Access Compliance Report

Public Rights-of-Way

(Pedestrian Signals)

Intersection ID: N/A	Main Street:	Cross Street: N/A	Location: N/A
ADA ID: 8D4FE90F7FBC	Signal Type: Two Push Buttons-Non APS	Overall Compliance: No	Severity Score: BTN 1:N/A BTN 2: N/A No BTN: N/A
Codes/Mitigation Info/Possible Solution		Field Measurements/Component Compliance

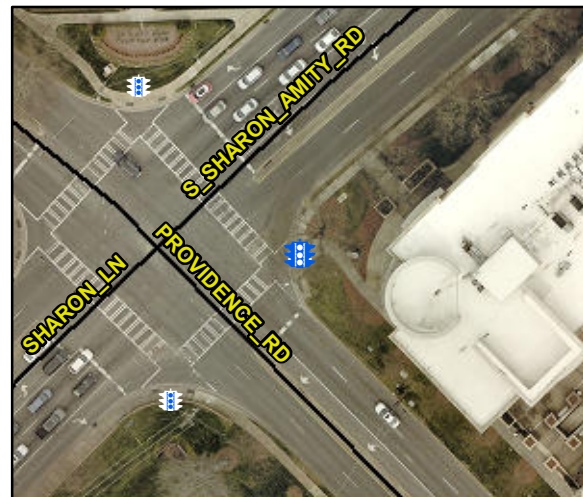
PROW/ADA: TMUTCD 4e.08, R406.2

Yes	B 1 Clear Xing Direction?	ClearlyMarked	Yes	B 2 Clear Xing Direction?	ClearlyMarked
	B 1 Crossing Direction	To NW		B 2 Crossing Direction	To SW
No	B 1 DistanceTo XWalk (in)	81.0	Yes	B 2 DistanceTo XWalk (in)	57.0
Yes	B 1 DistanceTo Curb (in)	68.0	Yes	B 2 DistanceTo Curb (in)	68.0
Yes	B 1 Diameter (in)	2.0	Yes	B 2 Diameter (in)	2.0

Possible Solutions: Replace Signal Push Button With APS Button on New Post. Remove & Relocate Sign. Provide Push Button Extension.
